ADDENDUM NO. 2 TO PROJECT NO. 44304

**CONSTRUCTION WORK
REPLACE WINDOW'S
HOUSING UNITS 1, 2, 4 and 9
MIDSTATE CORRECTIONAL FACILITY
P.O. BOX 216, RIVER ROAD
MARCY, NY 12589-0286**

February 10, 2015

AD2-01

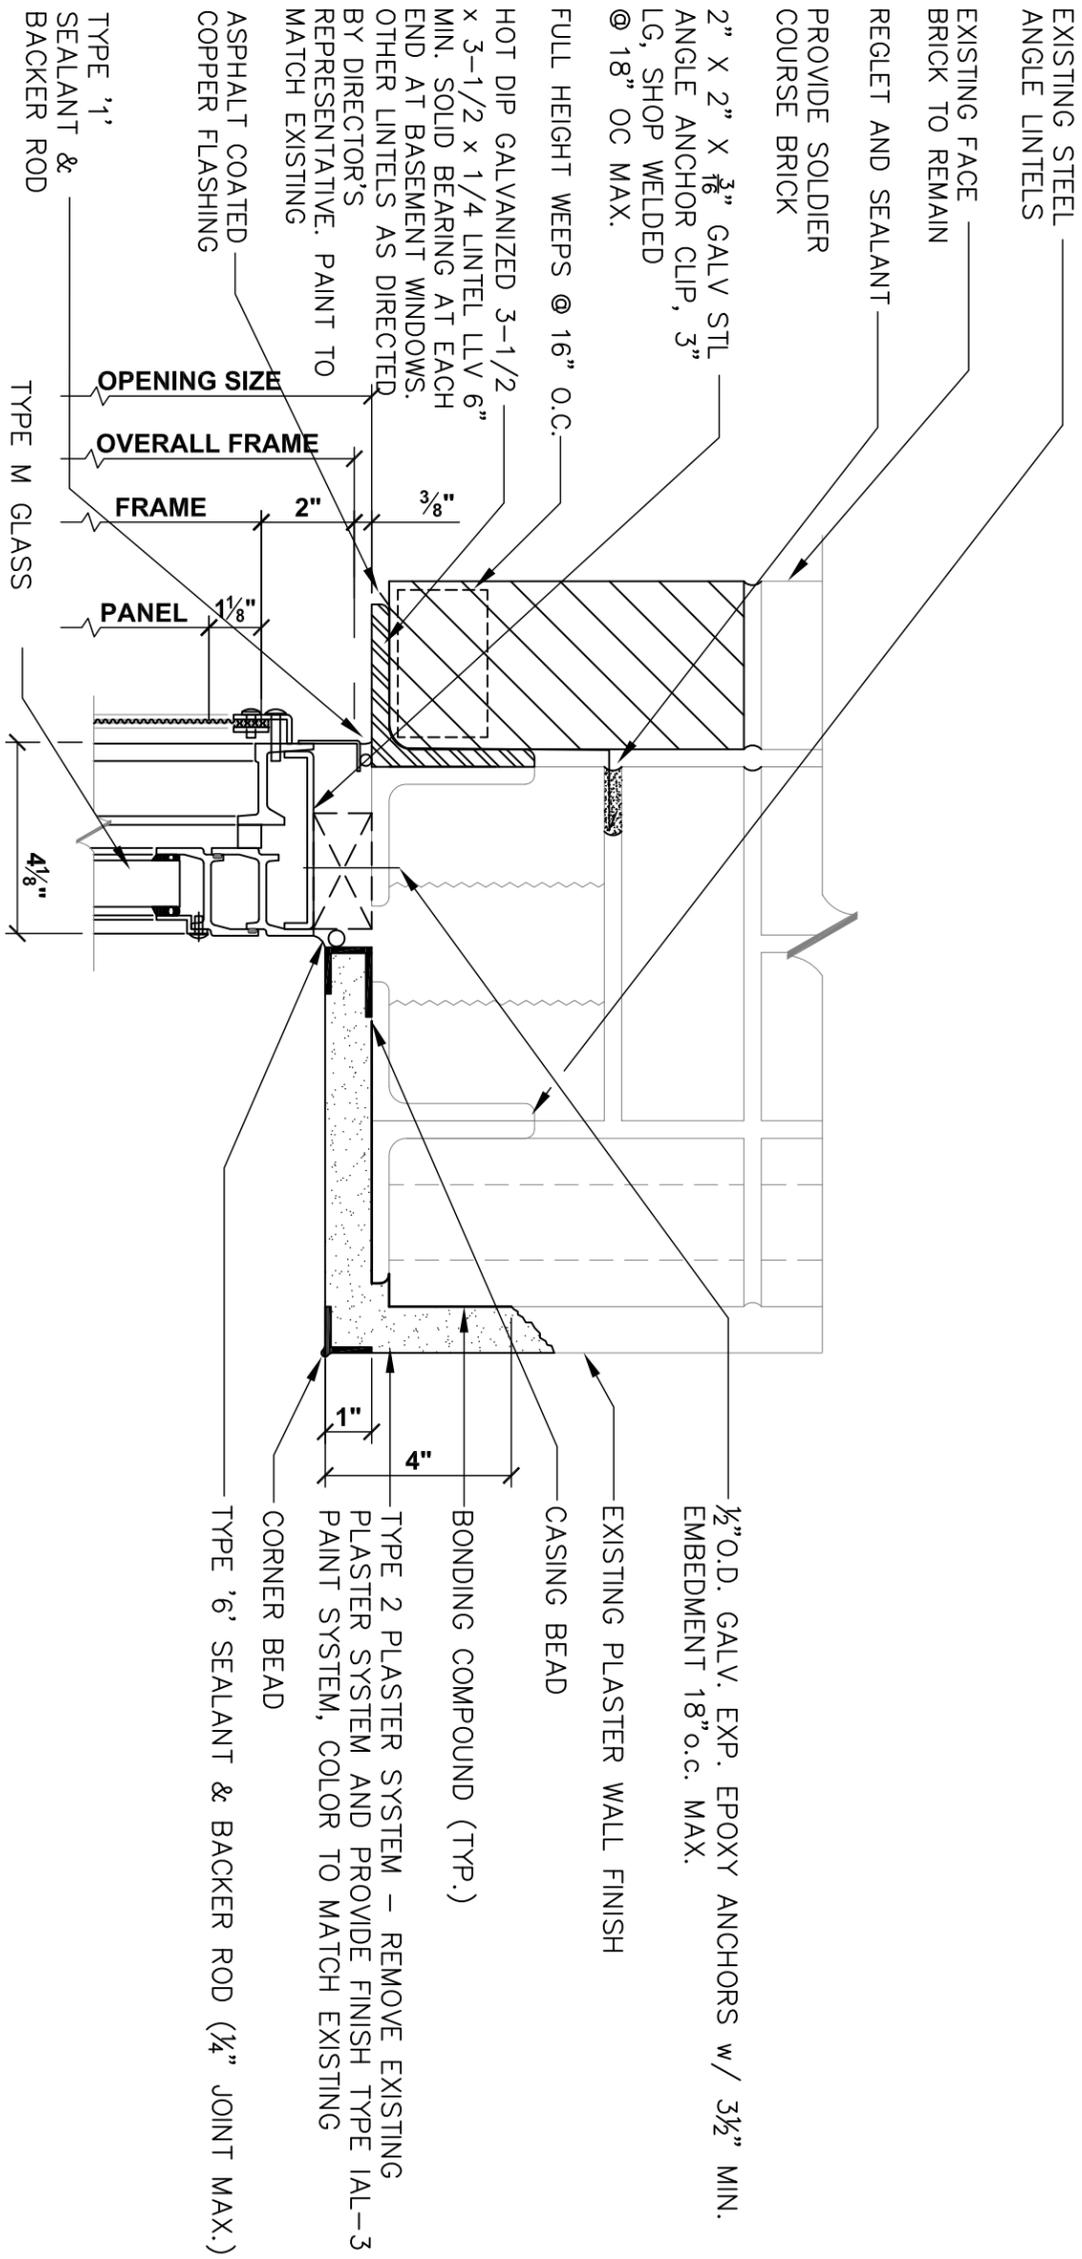
- d. Replace detail 1/A502 with the attached AD2-01
5. Drawing No. A-504
 - a. Omit details 1, 2, and 3.
6. Drawing No. A-506
 - a. Change detail 7/A506 wording from ' stainless steel hinge...' to ' electro-plated hinge...'
